Central Precinct Renewal Program

Water Quality, Flooding and Stormwater Addendum Report

September 2023 transport.nsw.gov.au

Figure 2: Existing Conditions Flood Function for the PMF event

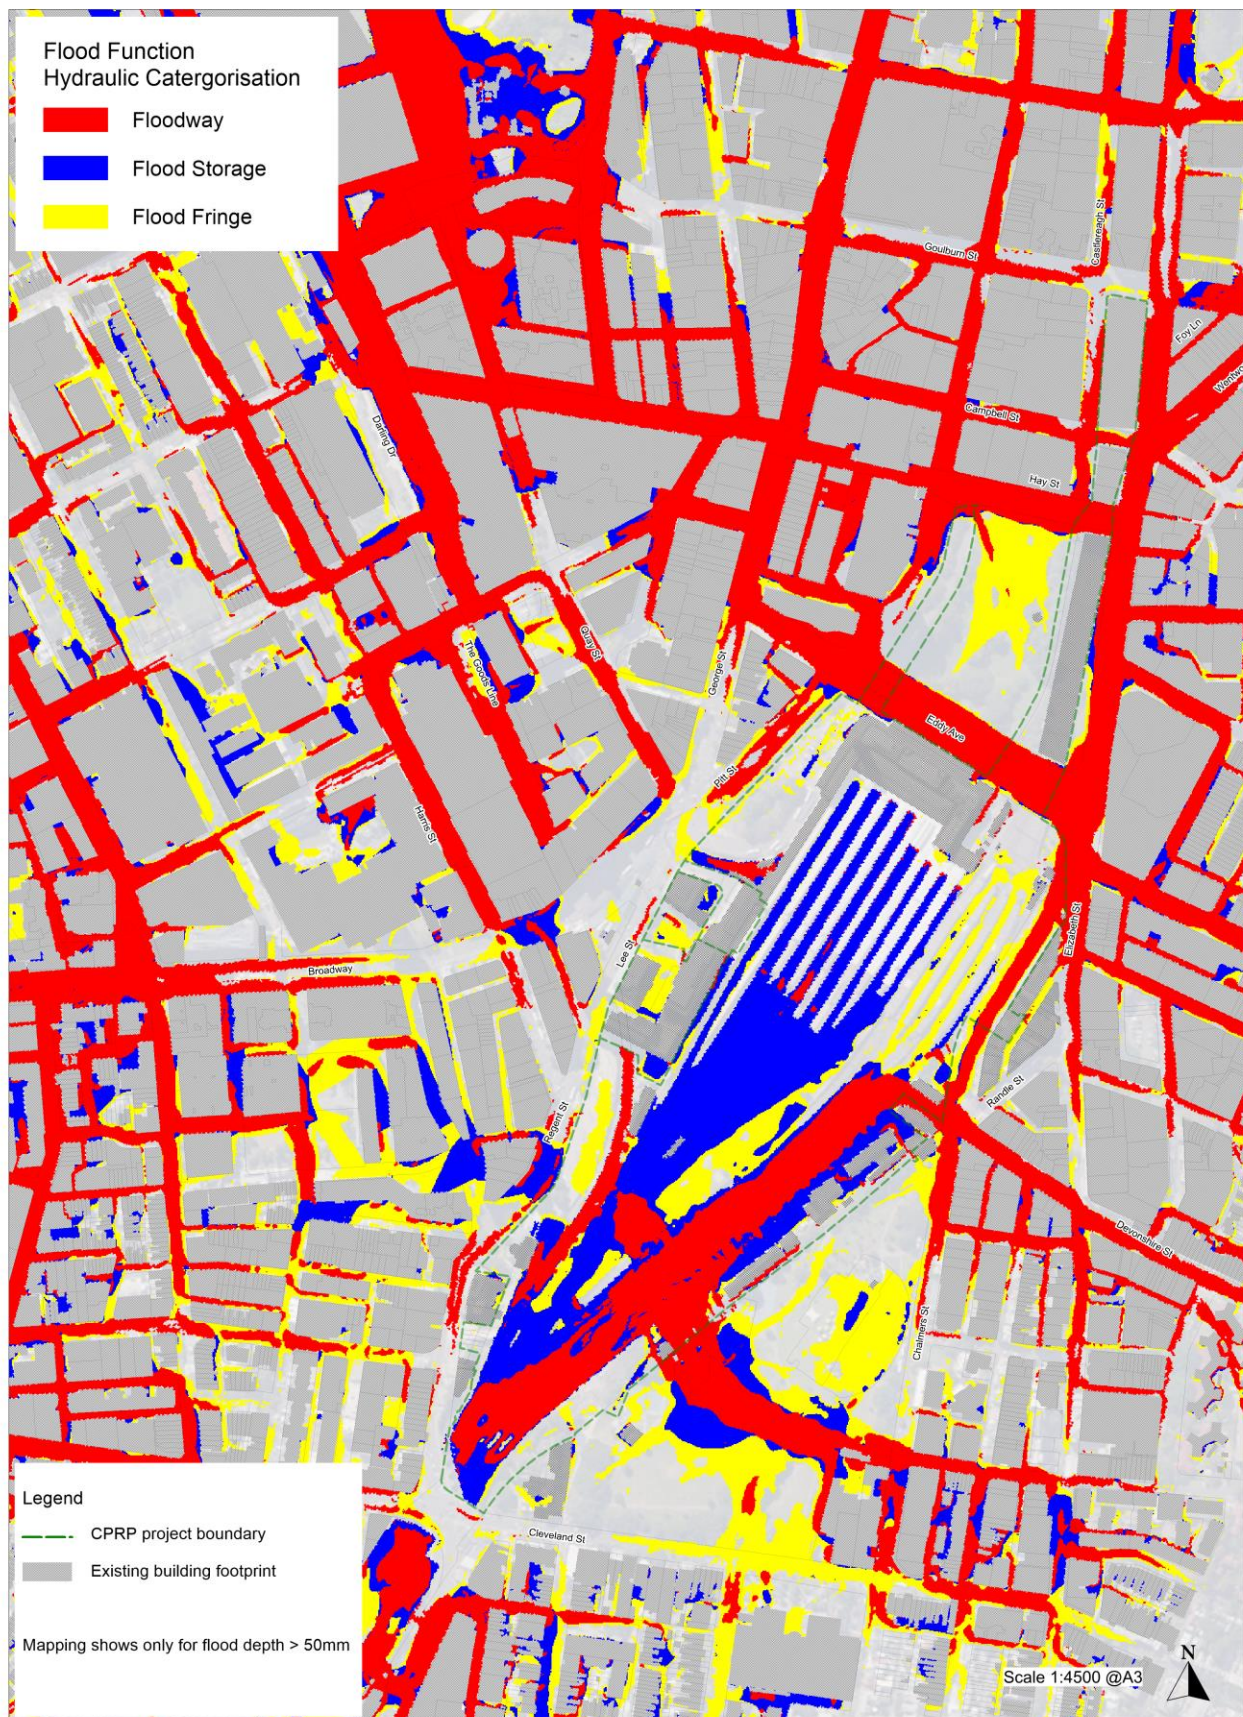
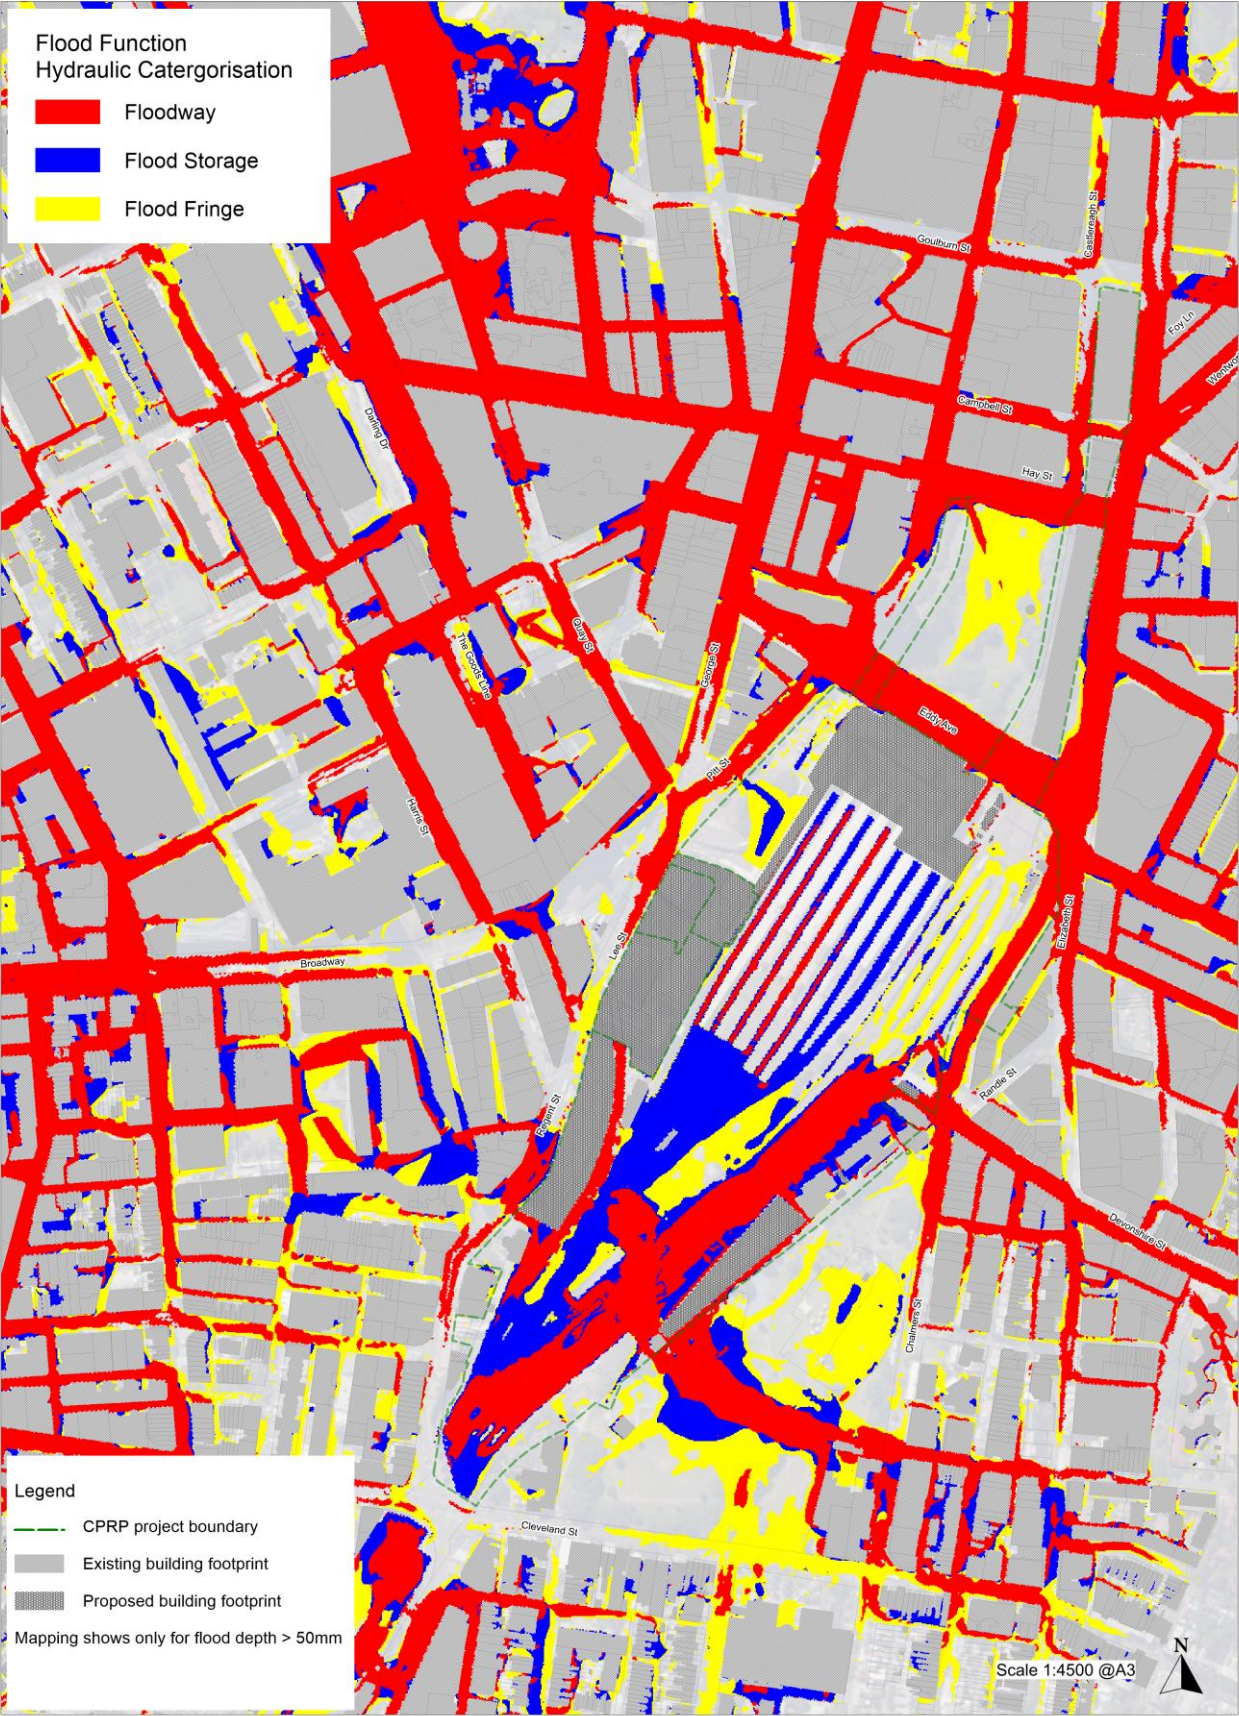
The Department of Planning and Environment sought independent flooding advice from Rhelm. The documented advice issued to TfNSW recommends the consideration of a wider range of flood events, including climate change, and for the SSP study to include mapping of the flood planning area and flood function.

Flood function mapping for the existing and proposed conditions for the PMF event are provided below in **Figure 2** and **Figure 3**.

The flood function has been defined based on the following hydraulic categories:

- Floodway: Velocity x Depth > 0.25m²/s AND Velocity >0.25m/s OR Velocity > 1m/s
- Flood Storage: Land outside the floodway where Depth > 0.2m
- Flood Fringe: Land outside the floodway where Depth < 0.2m
